Cannon Beach Planning Commission

Staff Report Addendum (10:00 AM February 24, 2022)

PUBLIC HEARING AND CONSIDERATION OF **AA 22-01**, GREG HATHAWAY'S, ON BEHALF OF JEFF AND JENNIFER HARRISON, APPEAL OF THE CITY'S ADMINISTRATIVE APPROVAL OF A BUILDING/DEVELOPMENT PERMIT FOR 534 NORTH LAUREL STREET. THE PROPERTY IS LOCATED AT 544 N. LAUREL STREET (TAX LOT 07002, MAP 51019AD), AND IN A RESIDENTIAL MEDIUM DENSITY (R2) ZONE. THE REQUEST WILL BE REVIEWED PURSUANT TO MUNICIPAL CODE, SECTION 17.88.180, REVIEW CONSISTING OF ADDITIONAL EVIDENCE OR DE NOVO REVIEW AND APPLICABLE SECTIONS OF THE ZONING ORDINANCE, CONDITIONS OF APPROVAL OF THE CANNON BEACH PRESERVATION PLANNED DEVELOPMENT SUBDIVISION AND APPROVED PLAT.

Prepared By: Jeffrey S. Adams, PhD

GARAGE ELEVATIONS

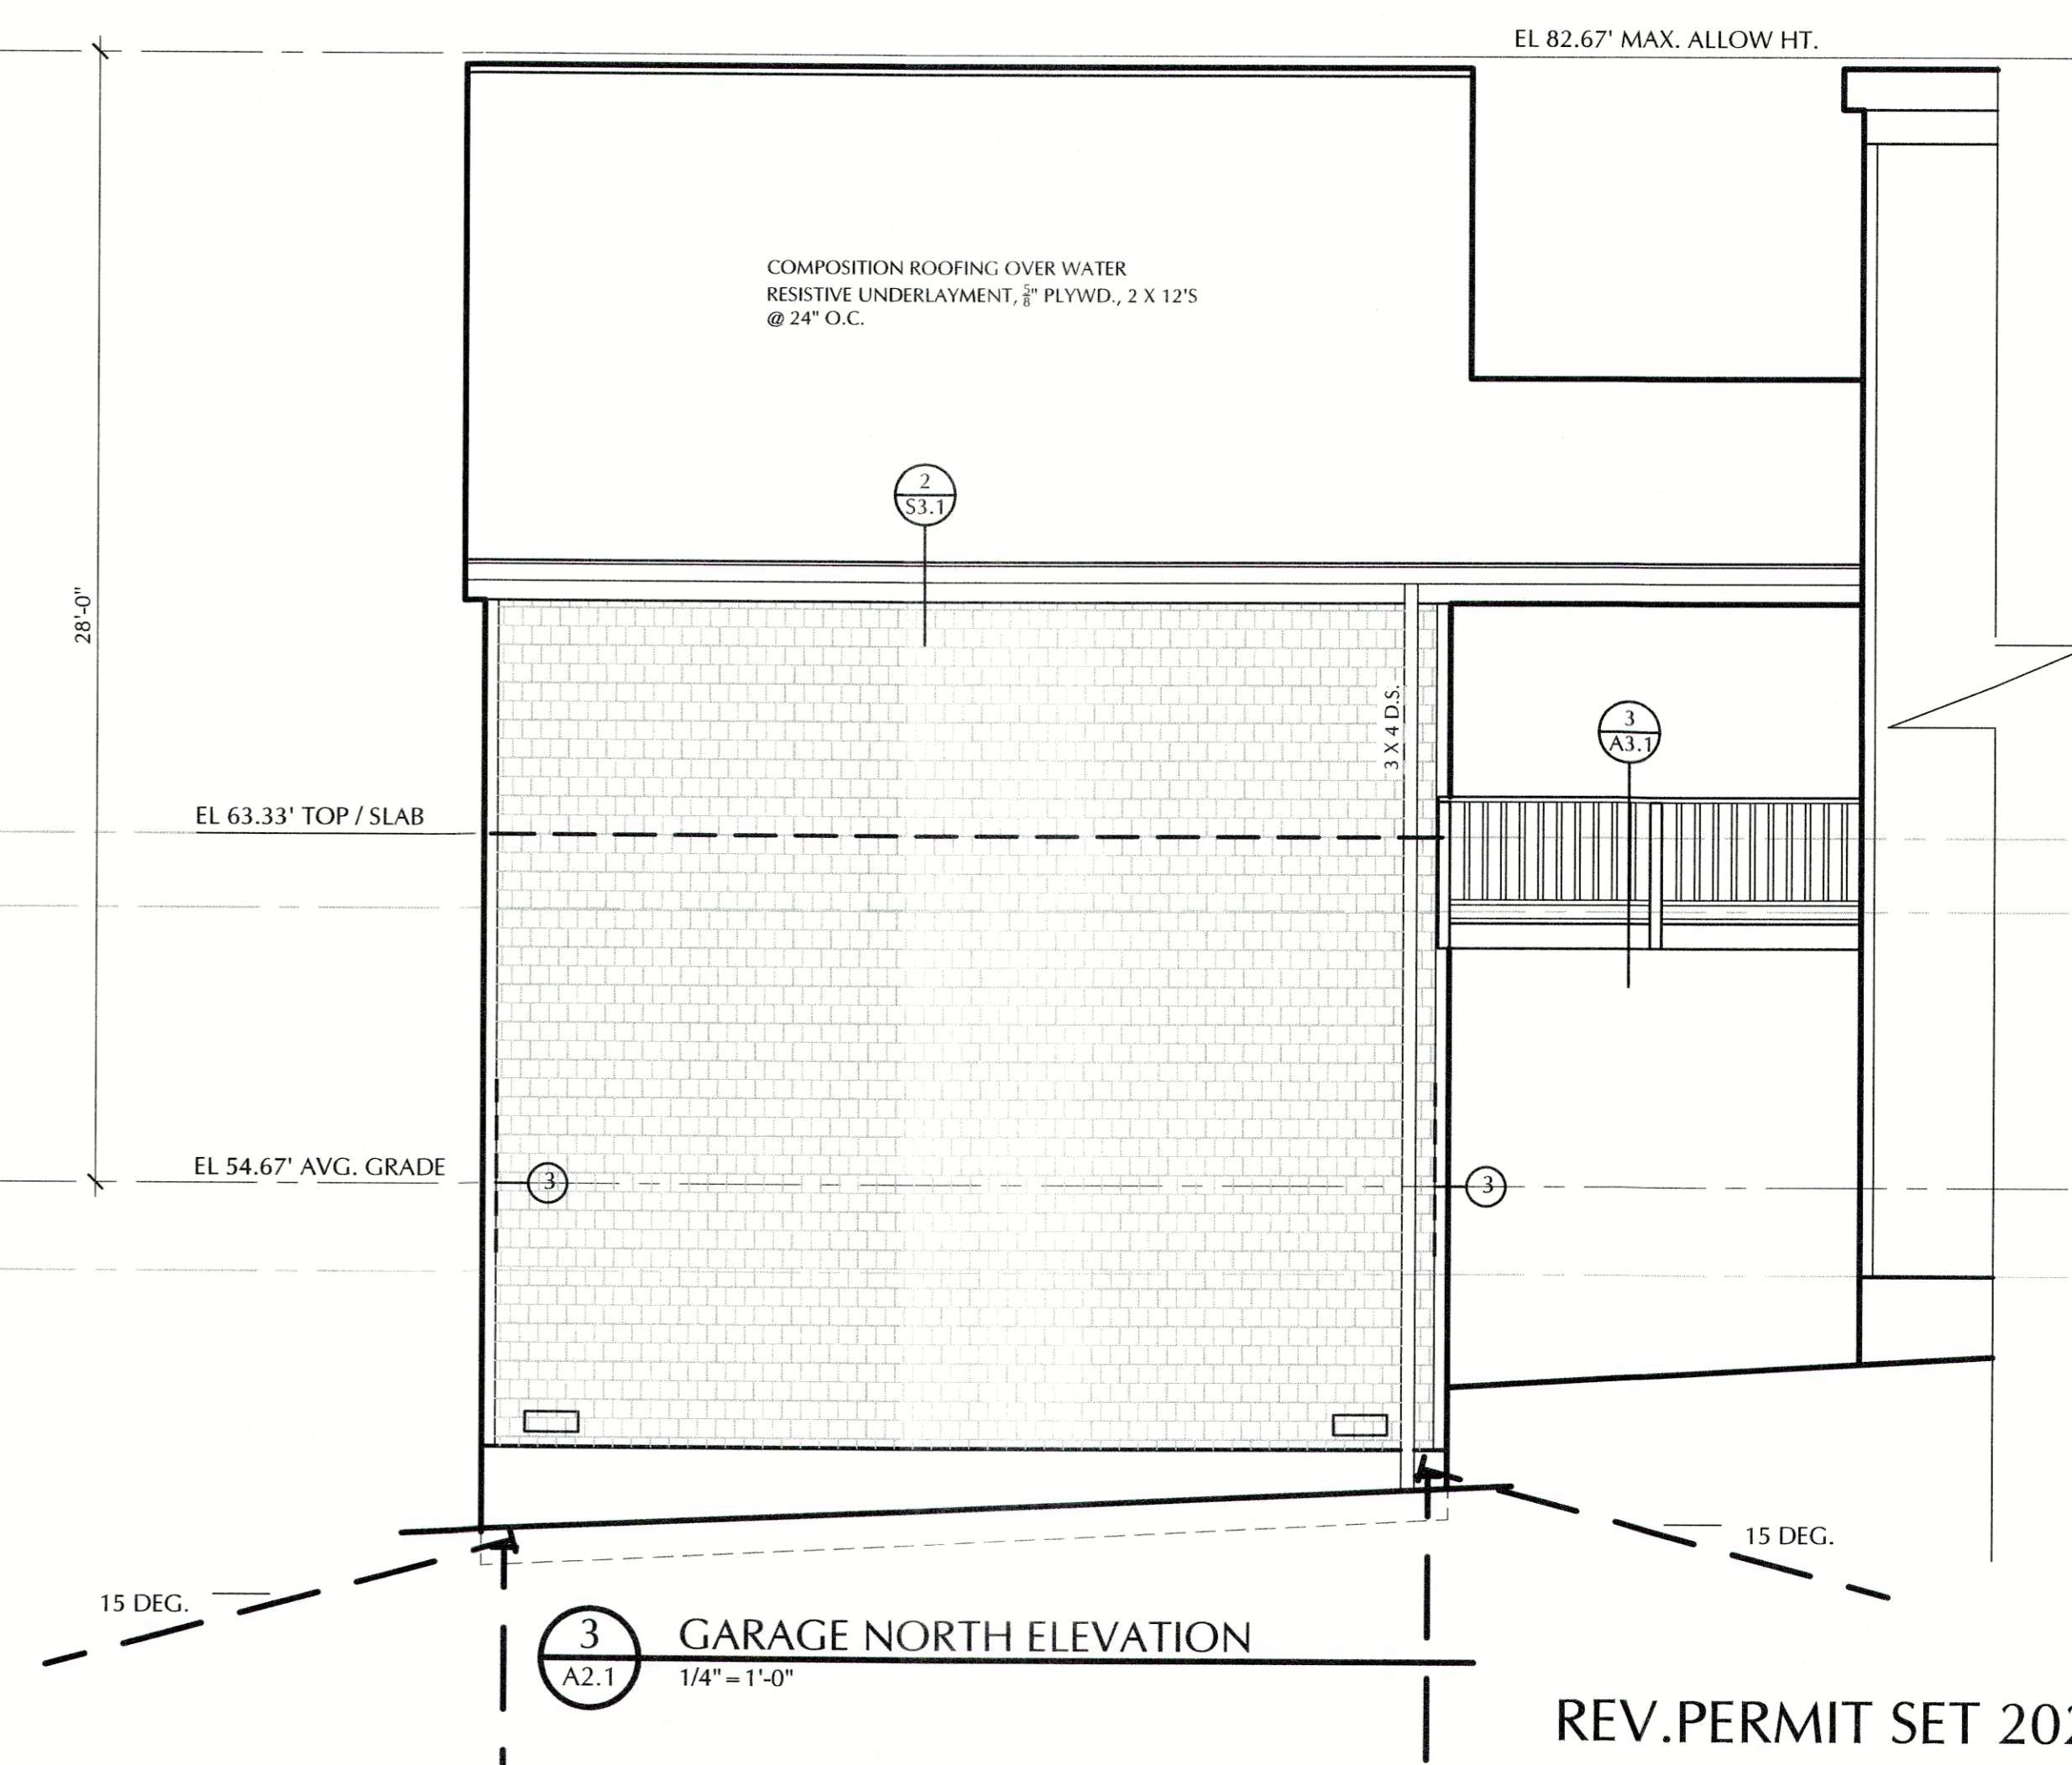
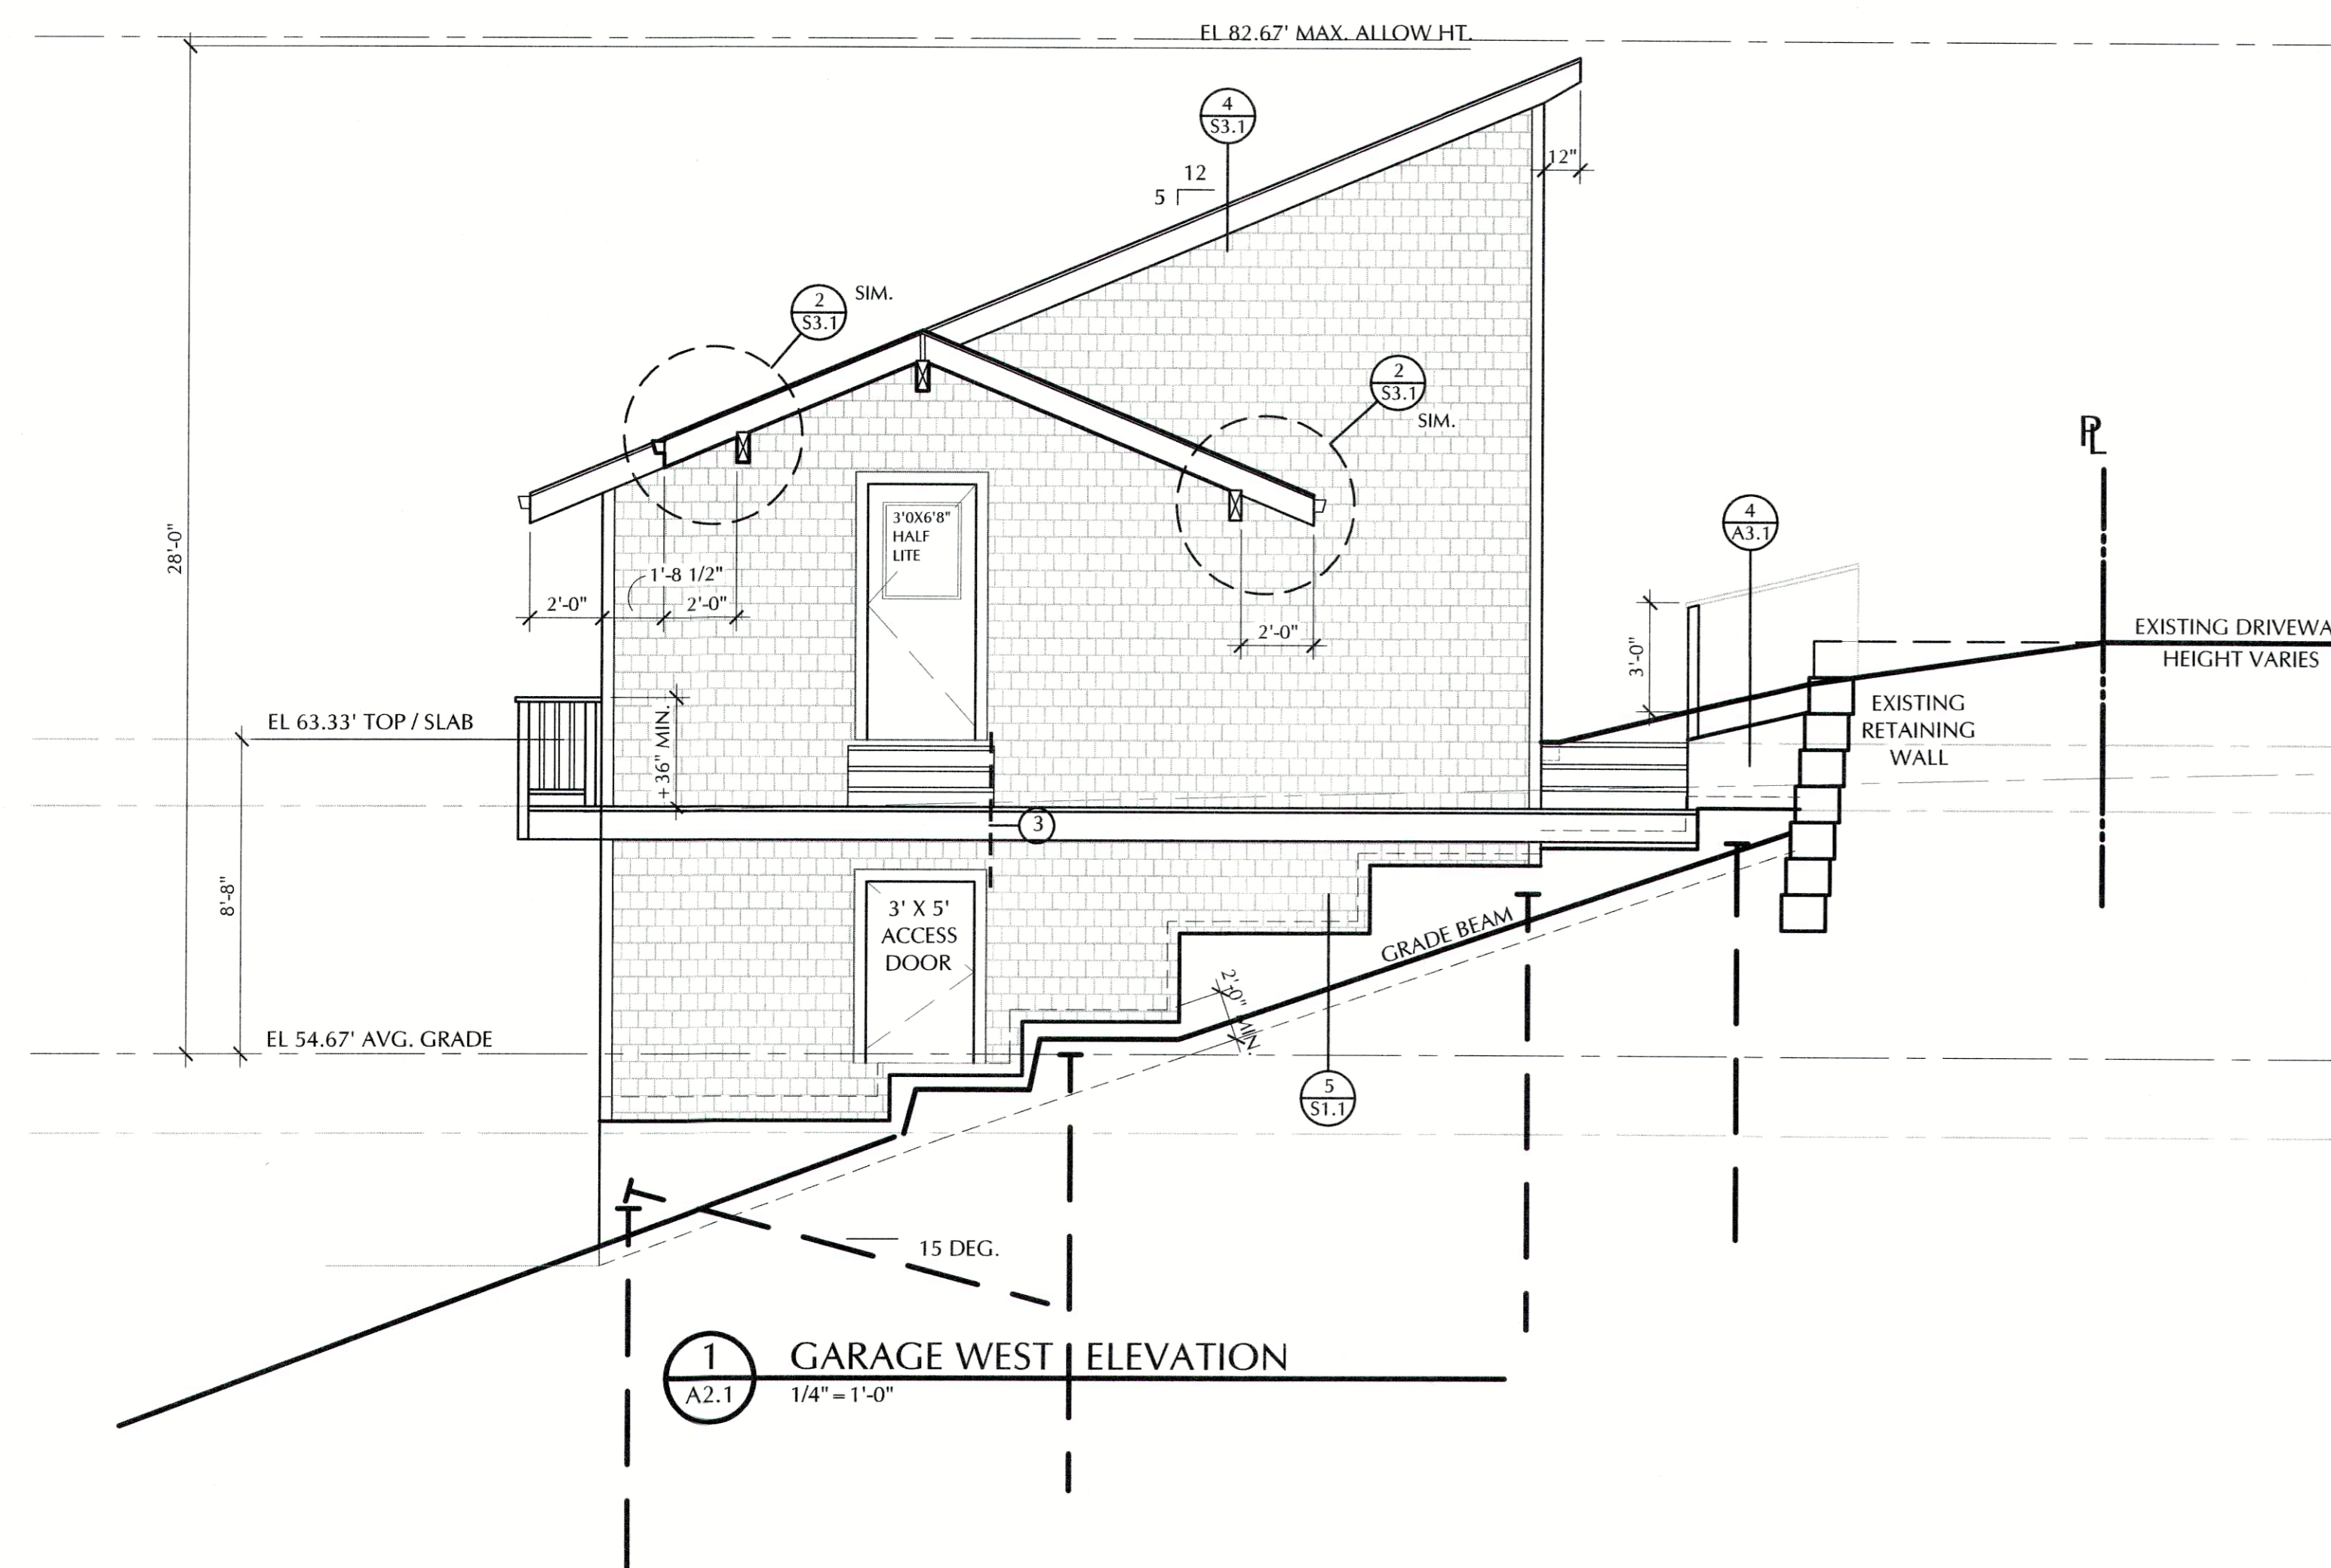
The submitted and approved building plans for the detached two-story garage show two distinct areas: (1) an upper space for parking two vehicles and (2) a lower space that is substantially above grade. In particular, the lower space:

Because the height of the lower area between the average grade and finished surface of the floor of the parking area above measures over 6 feet for more than 50% of the total area, and the finished floor of the parking area appears to measure more than 12 feet above the finished ground at the tallest point, the Planning Commission finds the lower area of the proposed detached garage qualifies as a story and a story above grade plane.

Because height of the lower area between the average grade and finished surface of the floor of the parking area above measures over 6 feet, and the finished floor of the parking area appears to measure more than 12 feet above the finished ground at the tallest point, the Planning Commission finds the lower area of the proposed detached garage qualifies as a story and story above grade plane. Therefore, the proposed garage is a detached 2-story garage and violates PUD Condition No. 16.

Therefore, the Planning Commission concludes that the issued Building Permit violates PUD Condition No. 16 since the proposed detached garage is a two-story garage.
